Subject: U - 77778
Plan of Operations - Diatomaceous Earth Quarry – Skull Valley, UT

3809
U-77778
(UT-023)

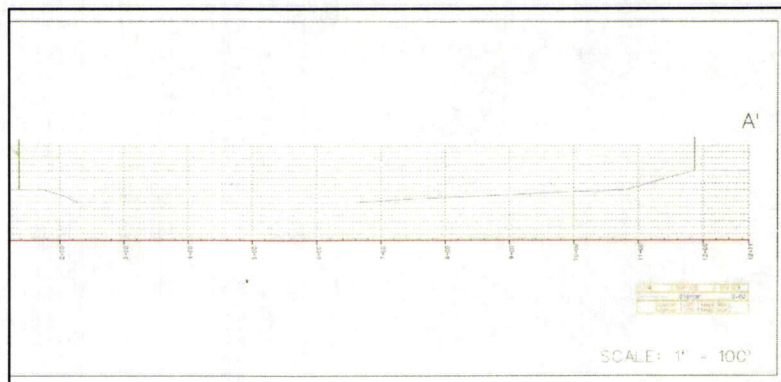
1. The Plan mentions that CRLI will stockpile overburden material for later use in reclamation. Submit a map identifying the location of the stored topsoil used for concurrent and/or final reclamation. On the stored topsoil map or a topography map note all of the existing access route(s) planned for hauling.
2. In your submitted Plan, you indicate that the pit walls would be re-contoured into a broad, shallow depression. Please specify the approximate final slope for the pit walls. Also, include a sketch of the anticipated topography after pit reclamation.

The final slope into the shallow depression will be 3:1, i.e. three horizontal units to one vertical unit. Attached is a cross-section depicting a slope contour.
